ADEQUACY OF STATION ELECTRIC DISTRIBUTION SYSTEM

VOLTAGES, MONTICELLO NUCLEAR GENERATING PLANT, UNIT 1

Accession No. \_\_\_\_\_  
Report No. EGG-EA-5783

Docket No. 50-263

Figure 1. Monticello Electrical Single-Line Diagram

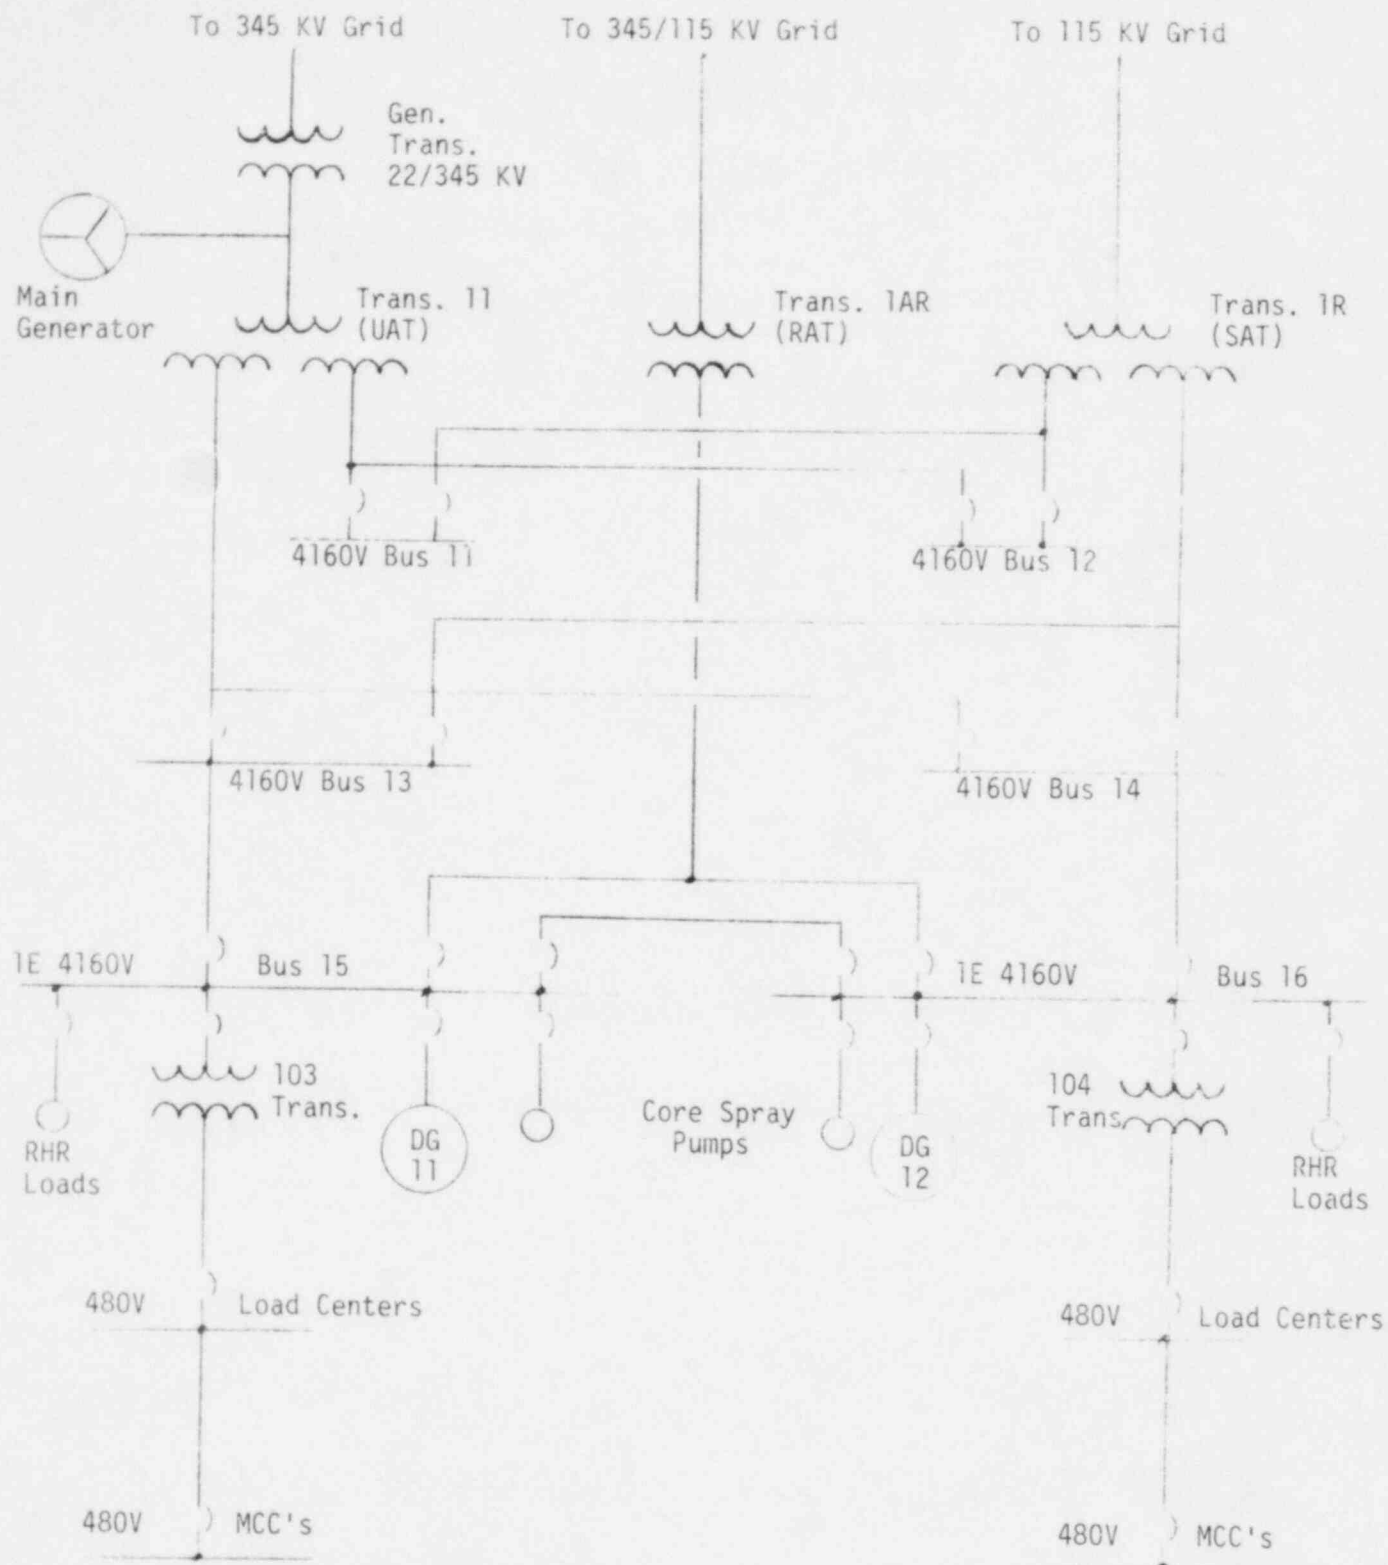
Figure 1 of this report is a simplified sketch of the Monticello electrical single-line diagram.

During normal plant full-power operation, auxiliary power is supplied by the Unit Auxiliary Transformer (UAT) No. 11 and, during startup and shutdown, by the Startup Auxiliary Transformer (SAT) No. 1R. Provisions are made for automatic, fast transfer of the auxiliary loads from the UAT to the SAT upon unit trip. Inability of the SAT to supply power will cause an automatic transfer to the Reserve Auxiliary Transformer (RAT) No. 1AR.<sup>2</sup> Complete loss of all offsite power will result in the diesel generators supplying all the shutdown loads. The UAT and SAT each have the capacity to carry full plant loads. The RAT and the diesel generators have the capacity to supply all safety-related loads (all non-essential loads are automatically shed).

There are two essential 4.16kV buses; No. 15 and 16. One division of safety-related equipment is powered from each of these buses. Each bus supplies 4.16kV loads, the 480V load centers and motor control centers (MCCs), and the 250V dc, 125V dc, and 24V dc systems.
